**MODIFICATION REQUEST:
Homebush Bay Bridge Modification 1
Homebush Bay, between Wentworth
Point and Rhodes
(MP10_0192 MOD 1)**

Modification to bridge design

Director-General's
Environmental Assessment Report
Section 75W of the
Environmental Planning and Assessment Act 1979

February 2014

Figure 3: Proposed layout (Designs Revisions Report Nov 2013)

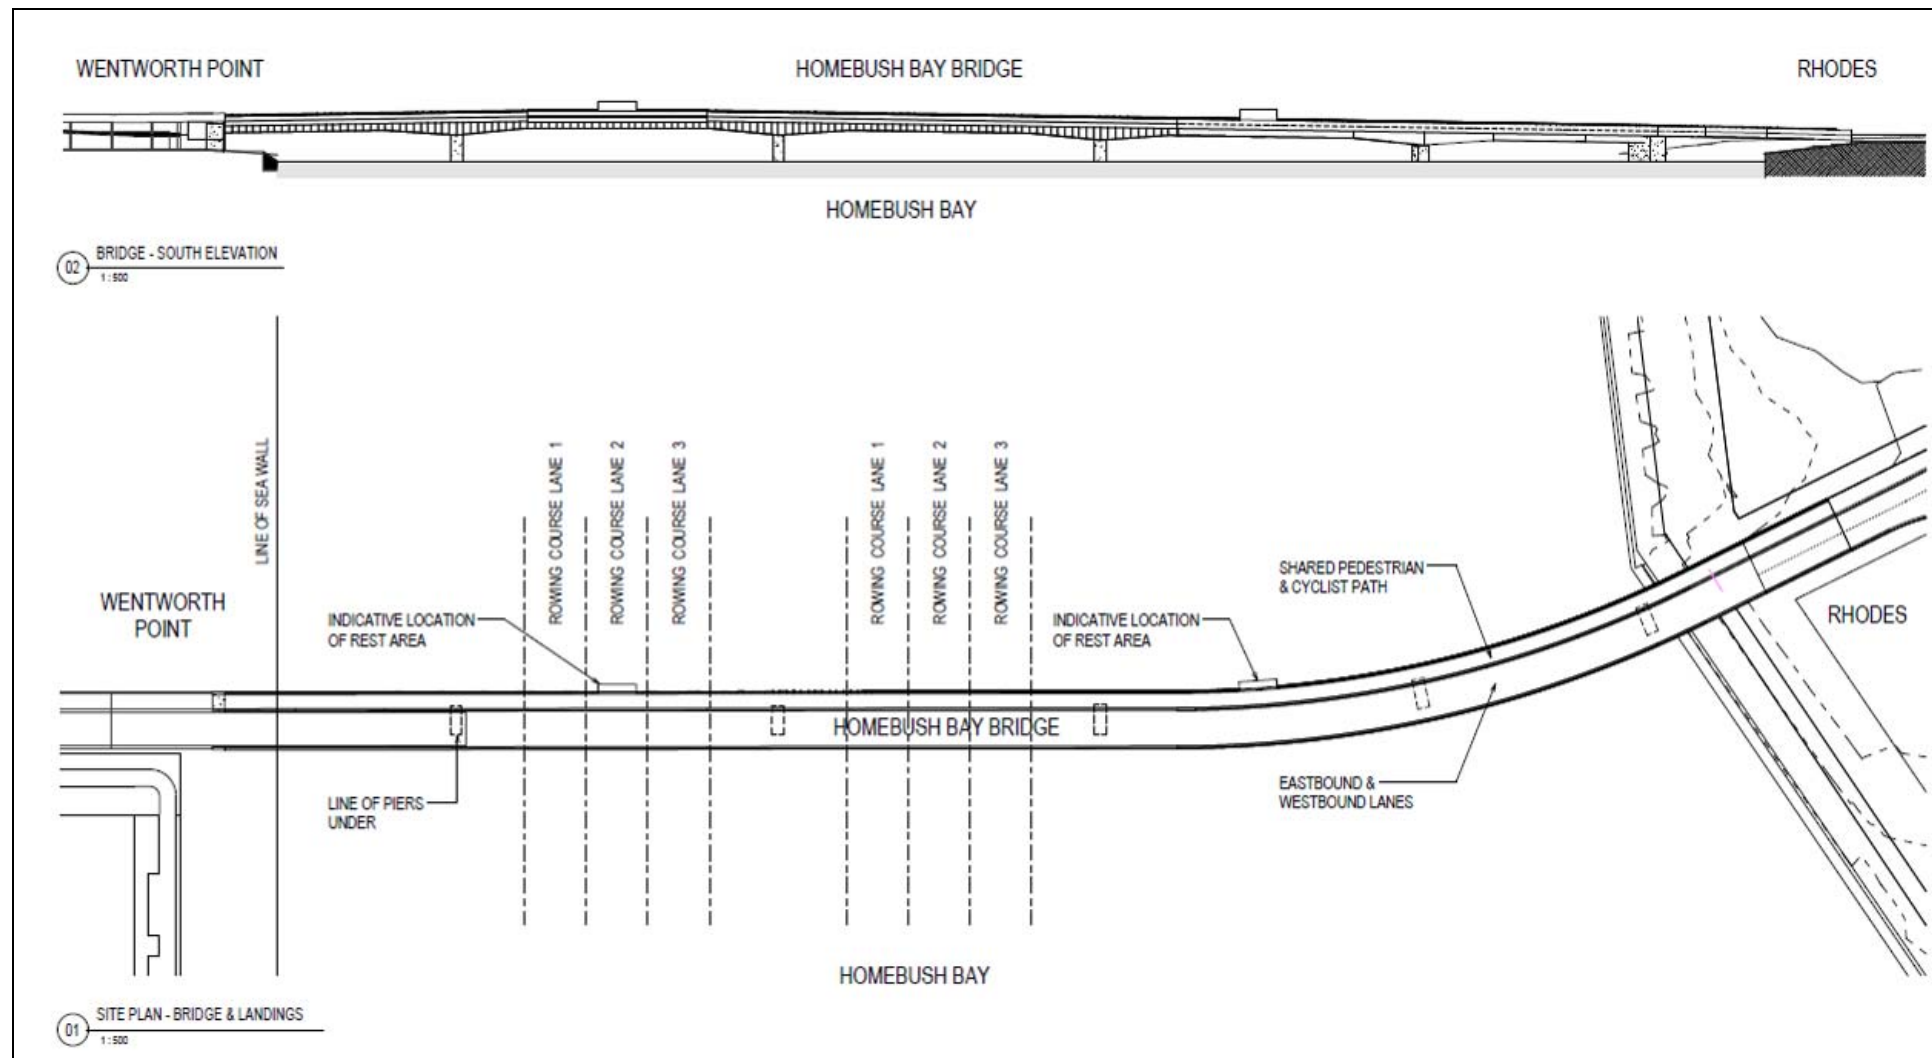
The proposed modification includes adopting a balanced cantilever pre-cast bridge construction method. The new methodology would result in a reduction in the number of piers in Homebush Bay from 36 to 5. Spacing of the main bridge piers would increase from 51 metres to 68 metres.

Grade separation is proposed at Rhodes where the bridge meets the peninsula. The separation will eliminate a level crossing with bus traffic and allow for an improved pedestrian and foreshore cycleway.

The approaches to Wentworth Point have been designed as an elevated roadway to provide access to Hill Road prior to the planned completion of the remaining roads at Wentworth Point.

The Proponent has identified that Condition of Approval B9 (which requires that the landing height at Rhodes is no higher than RL 3.0 metres) is inconsistent with the proposed modification and requests its deletion.

The Proponent has requested the deletion of Condition B9, which requires the bridge deck height at the Rhodes landing to be no higher than RL 3.0. Planning and Infrastructure does not support this deletion, as it is important to maintain a precise deck height to ensure that impacts are as assessed. Drawing PA-002 rev A depicts the revised deck height of RL 5.3, rising at a 1:40 grade to RL 5.8. It is recommended that Condition B9 be modified to require a deck height consistent with PA-002 rev A.

Figure 5: Comparative view impacts to Unit 1 (Source: Modification Environmental Assessment Dec 2013)

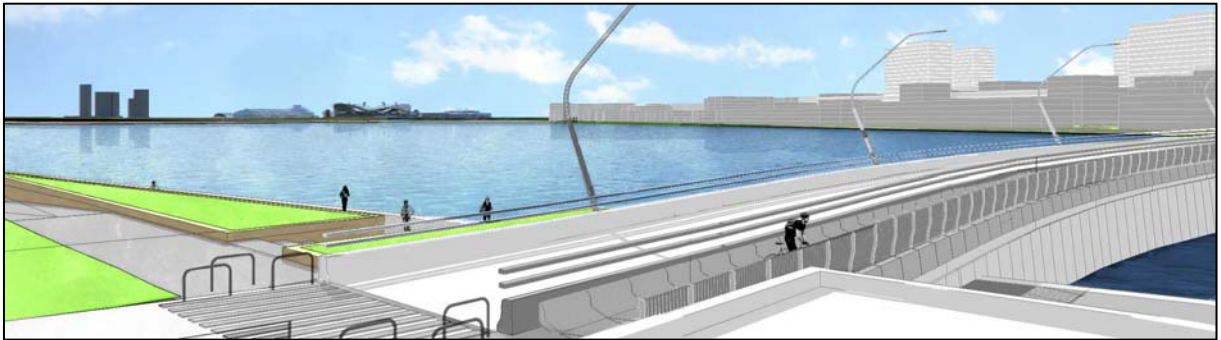
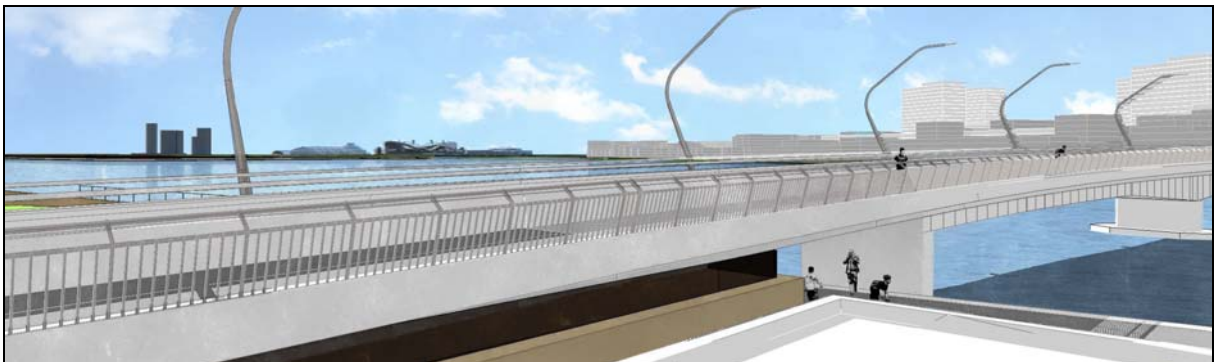
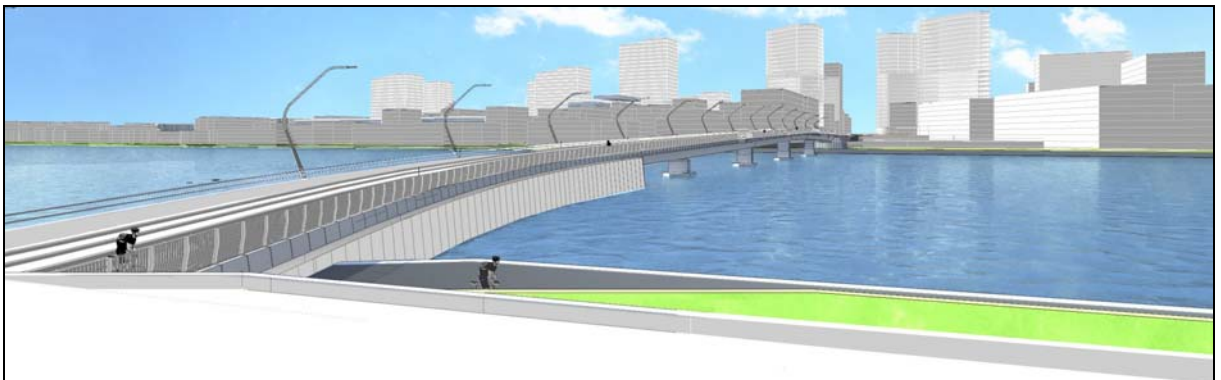
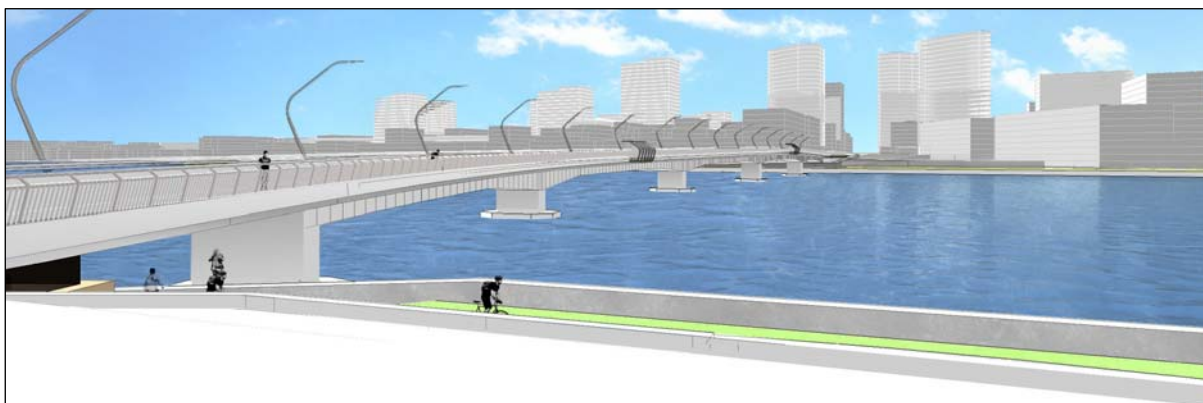
Quality of views affected: The affected view is to the west and south-west. These views are of the near (eastern) and far (western) shores of Homebush Bay, as well as the Olympic Park skyline, which is considered to be a local landmark.

Part of property affected: Views impacted from the proposal are from the terrace, living room and one bedroom. The terrace is partly enclosed and partly open. Because Unit 1 is the corner unit and the terrace is partly open, water views from the terrace are nearly 180 degrees. The living room has water views in two directions: west, via the glass doors to the terrace, and south, via a side window. The orientation of the unit and the partial enclosure of the terrace obstruct views from the living room to the south-west. The bedroom has a water view to the south. The parts of the property affected include highly valued spaces at the front of the unit and less valued spaces at the side of the unit.

Extent of impact: The proposal affects the views from the south facing windows and from the terrace. The south facing windows and the south-western view from the terrace will retain views of the western shore of Homebush Bay and the Olympic Park skyline, but will lose views of foreground water. Views to the west from the living room and the terrace lose some of the far view of the western shore on the southern side of the bridge but gain foreground water. The view from the terrace to the north-west is unchanged. This is an approximately 60 degree plane. Given that the modification does not completely remove water views in any direction, and largely retains the valued views from the living room and terrace, the extent of the impact is considered minor to moderate.

Reasonableness of proposal: The modification of the bridge is considered to be reasonable in so far as it improves public safety and the amenity of the public domain, as discussed in Section 5.3 below.

The proposal reduces the views from Unit 1 to the south and south-west, but retains views to the Olympic Park skyline and views to the west and north-west are unchanged. View impacts to Unit 1 are not considered to be unacceptable.

Figure 6: Comparative view impacts to Unit 3 (Modification Environmental Assessment Dec 2013)

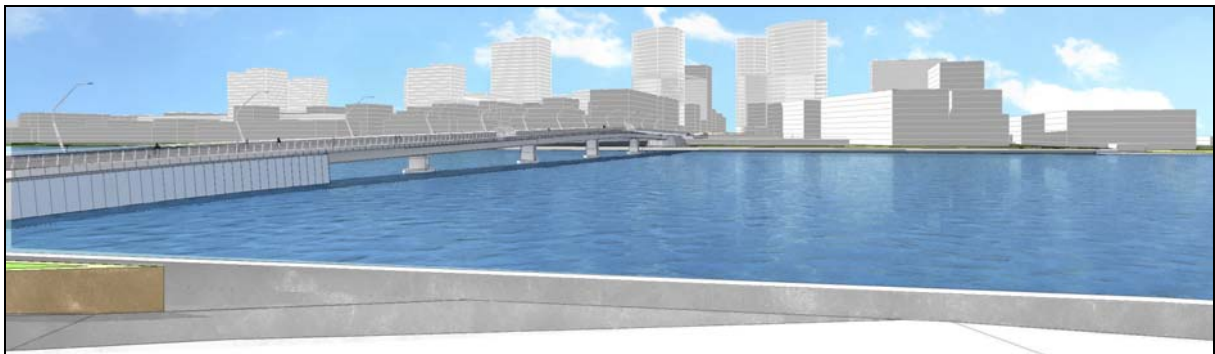
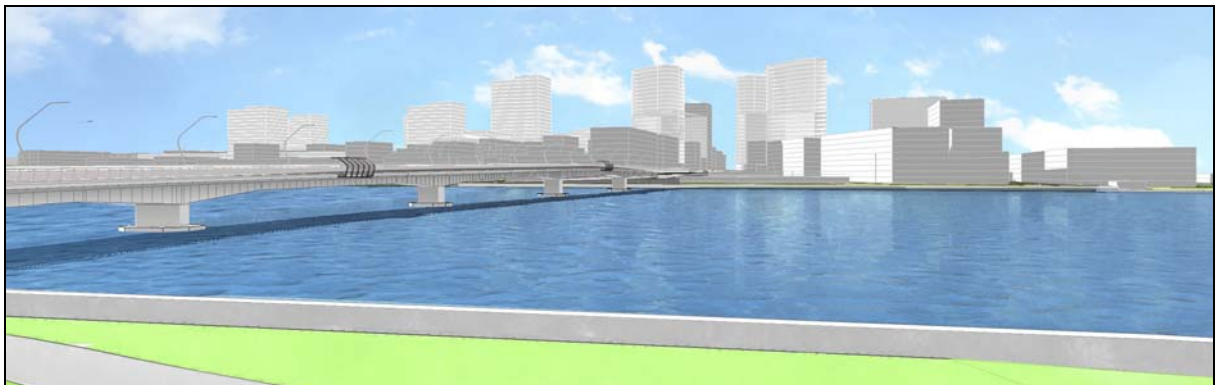
Quality of views affected: The affected view is to the west and south-west. This is a view to the near (eastern) and far (western) shores of Homebush Bay.

Part of property affected: Views impacted from the proposal are from the west facing terrace and living room. The terrace is open and affords approximately 135 degrees of water view. The parts

of the property potentially affected include the highly valued terrace and living rooms spaces at the front of the unit.

Extent of impact: The proposal removes a sliver of visible western shoreline on the southern side of the bridge. However, by removing the solid base section, it increases the foreground water view. The impact is considered neutral.

Reasonableness of proposal: As the proposal does not have a clear negative view loss impact, the reasonableness of the proposal is not a consideration.

The proposal has a neutral impact on Unit 3, which in any case enjoys substantial water views. View impacts to Unit 3 are considered acceptable.
